SUBJECT: ISSUANCE OF AMENDMENTS FOR THE PALO VERDE NUCLEAR GENERATING STATION
UNIT NO. 1 (TAC NO. M88599), UNIT NO. 2 (TAC NO. M88600), AND UNIT
NO. 3 (TAC NO. M88601)

The Commission has issued the enclosed Amendment No. 77 to Facility Operating License No. NPF-41, Amendment No. 63 to Facility Operating License No. NPF-51, and Amendment No. 49 to Facility Operating License No. NPF-74 for the Palo Verde Nuclear Generating Station, Unit Nos. 1, 2, and 3, respectively. The amendments consist of changes to the Technical Specifications (TS) in response to your application dated February 18, 1994, as supplemented by letter dated May 16, 1994.

The proposed amendments allow a reduced minimum temperature of 545°F for criticality for all three Units. Additionally, the minimum cold leg temperature for core power levels between 90% and 100% has been changed to 552°F for Units 1 and 3, (which is a reduction of 10°F from the previous TS requirement). These TS changes permit reactor operation at full power with a lower reactor coolant temperature to minimize potential steam generator tube degradation. The cold leg temperature reduction at power levels above 90% was not requested for Unit 2 due

FIGURE 3.2-1

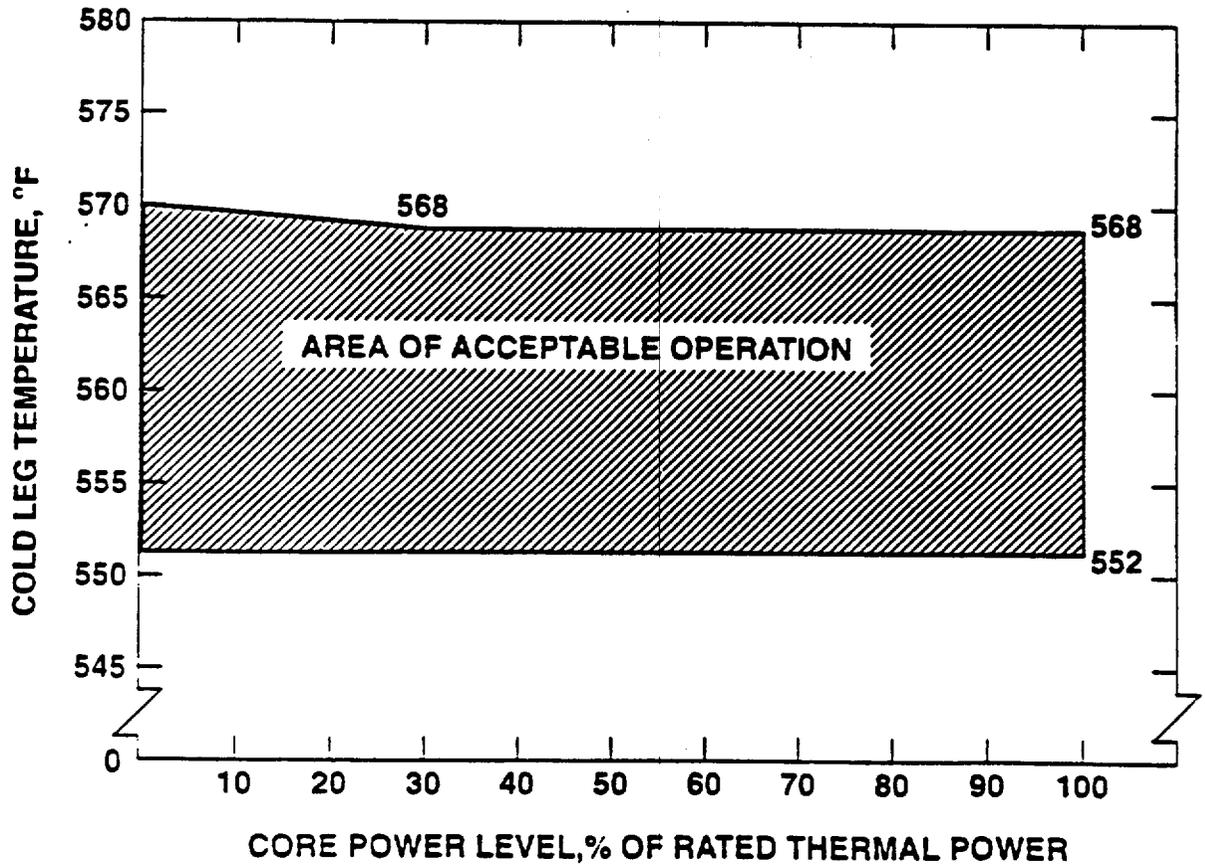
Currently, Figure 3.2-1 of the Palo Verde Units 1 and 3 Technical Specifications (TS) specifies a minimum cold leg temperature of 562°F for core power levels between 90% and 100%. In addition, TS 3/4.1.1.4 and its associated BASES for Palo Verde Units 1, 2, and 3 specify a minimum temperature of 552°F for criticality. These TS requirements are supported by the safety analyses documented in the Updated Final Safety Analysis Report (UFSAR). Operation of the Palo Verde units is currently restricted by an administratively imposed 10°F reduction in the reactor coolant cold leg temperature with reactor power restricted to 85% of rated core power to satisfy the current TS requirements. The licensee requested changes to the TS to allow Units 1 and 3 to operate at full power with a 10°F deduction in the reactor coolant cold and hot leg temperatures. The hot leg temperature reduction is needed to minimize the steam generator tube degradation, (e.g., primary water stress corrosion cracking (PWSCC)).

3.2.6 The reactor coolant cold leg temperature (T_c) shall be within the Area of Acceptable Operation shown in Figure 3.2-1.

For transients involving an increase in heat removed by the secondary system or a decrease in reactor coolant flow rate, the UFSAR analysis covers cold leg temperatures of 550°F and above; and therefore no new analysis is needed. Regarding transients involving a decrease in heat removal by the secondary system, the loss of condenser vacuum event is affected by a reduction in cold leg temperature and was reanalyzed assuming a cold leg temperature of 550°F. The results of the analysis are acceptable.

Additionally, cycle specific LOCA evaluations were performed for Unit 2, Cycle 5. These evaluations include a reduction in cold leg temperature of 10°F. The resultant peak clad temperature remains less than the current analysis of record limit of 2091°F, and the licensing basis limit of 2200°F. Based on the results of the Unit 2 evaluation and similarity among the three units, and the evaluations discussed above, a 10°F reduction in cold leg temperature is acceptable for Units 1 and 3.
